YEAR
1994

MODEL
LEGEND

BULLETIN NO.
95-002

Product Update: Legend Security System

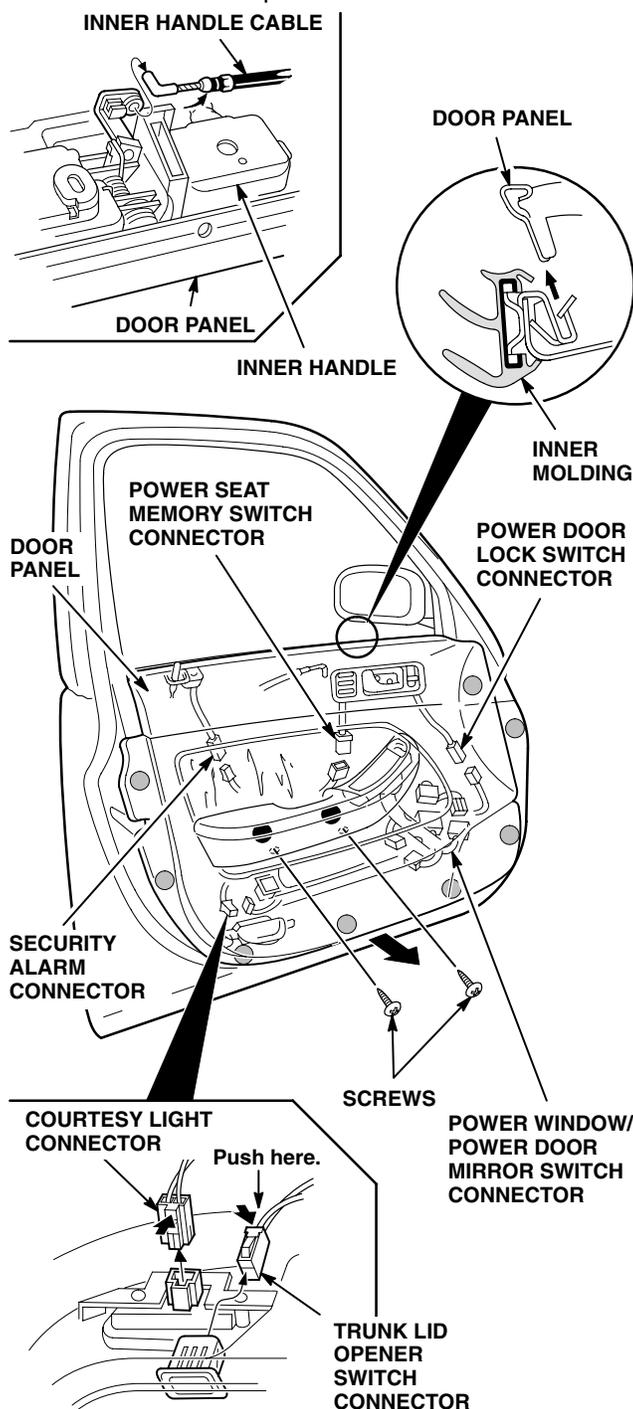
1. Remove the trim plate and screws from the inner door handle.

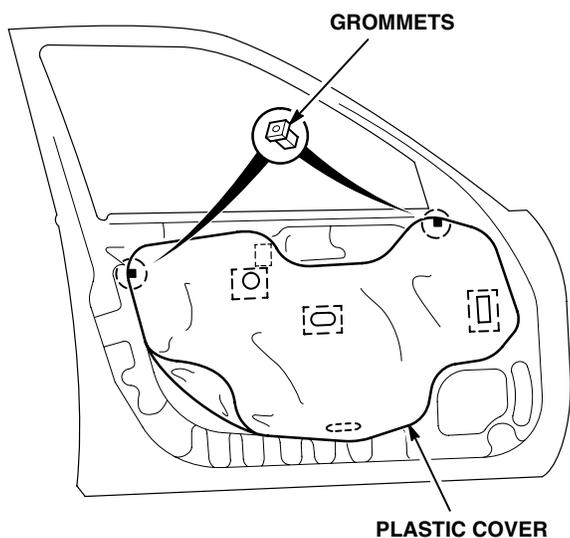
2. Remove the door panel.

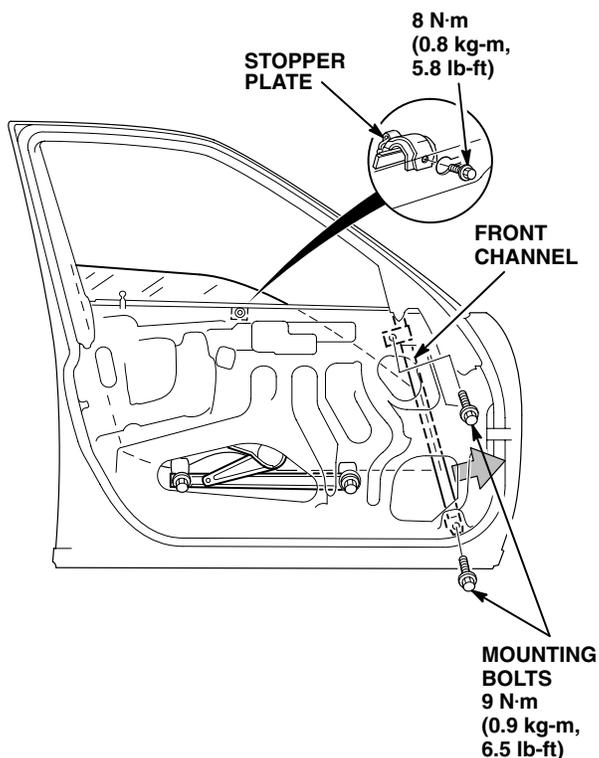
- Use a trim pad remover and a razor blade to remove the plastic cover.

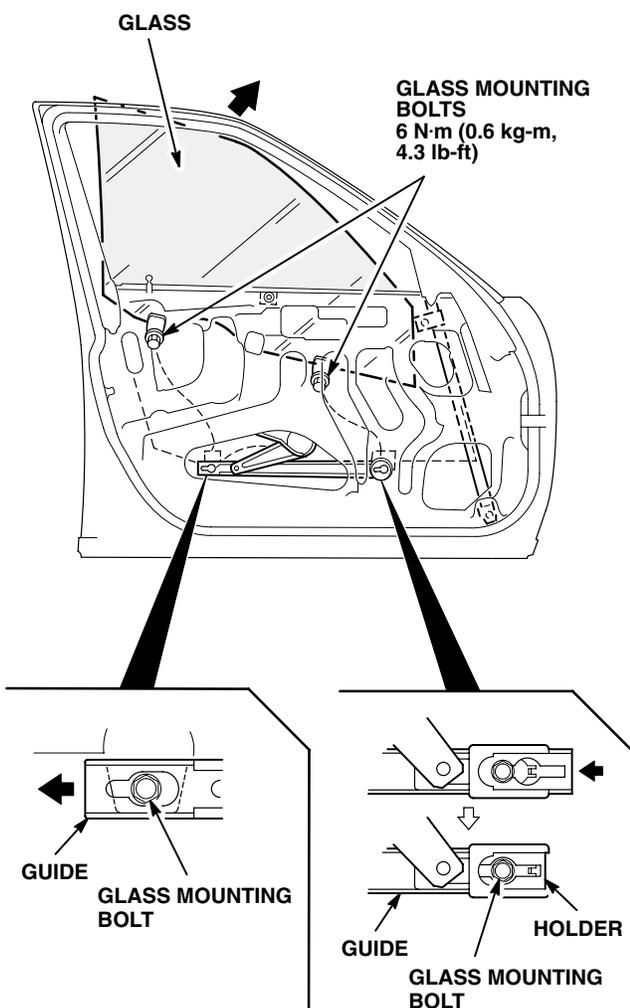
- Remove the inner molding.
- 4-door only:* Remove the stopper plate. Remove the mounting bolts, then slide the front channel forward.

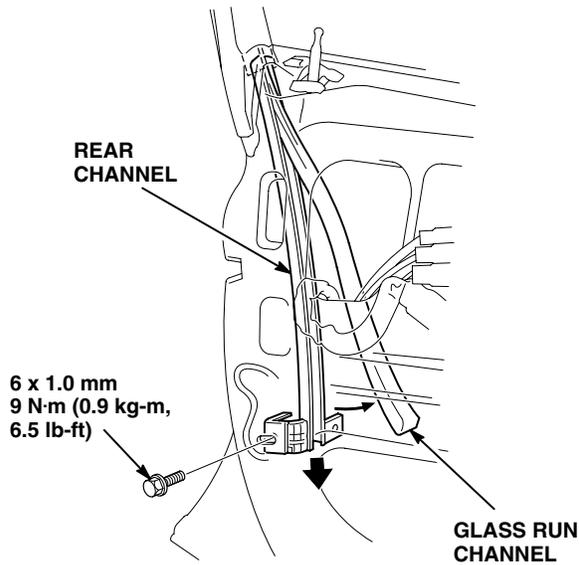
- Lower the window until you can see the glass mounting bolts. Loosen the bolts, slide the guide to the rear, and pull the glass out through the opening.

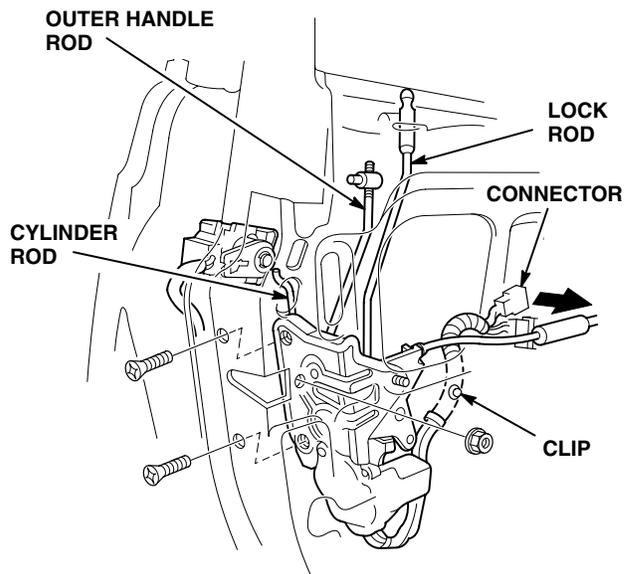
- Remove the glass run channel from the rear channel. Remove the mounting bolt, then remove the rear channel.

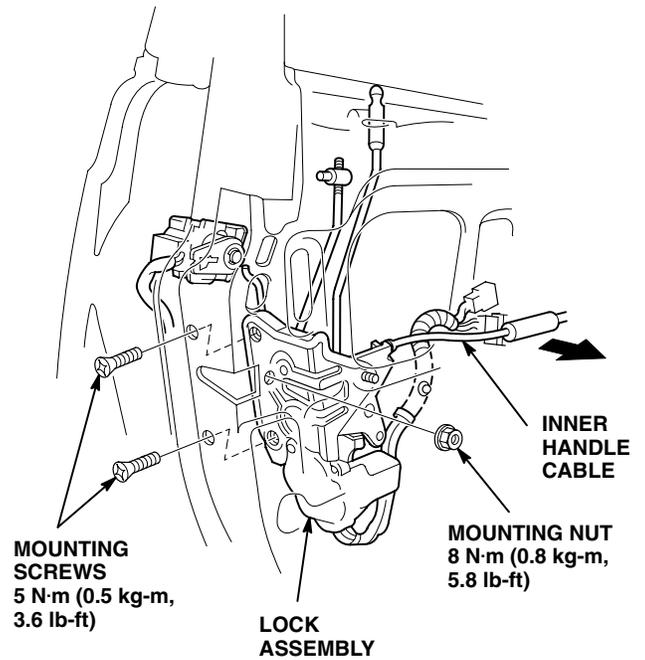
- Use a small flat tip screwdriver to pry the outer handle rod and cylinder rod out of their joints. Disconnect the electrical connectors for the lock assembly. Release the clip holding the wiring harness to the door.

- Remove the two mounting screws and the mounting nut. Remove the lock assembly from the door.

- Install the new lock assembly in the door. Adjust the length of the outer handle rod and reinstall it. Reinstall the cylinder rod, connect the electrical connectors, and clip the harness to the door.

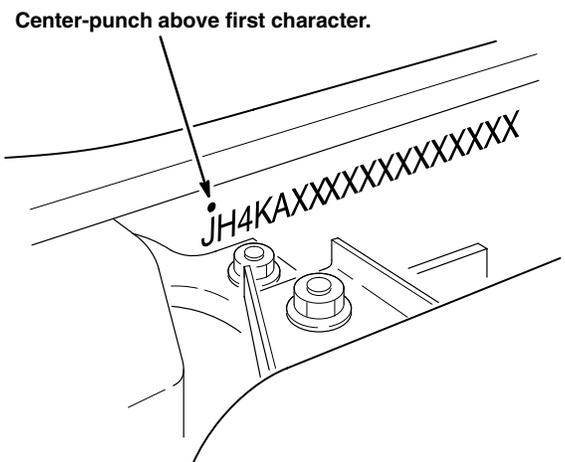
- Center-punch a completion mark above the first character of the engine compartment VIN.
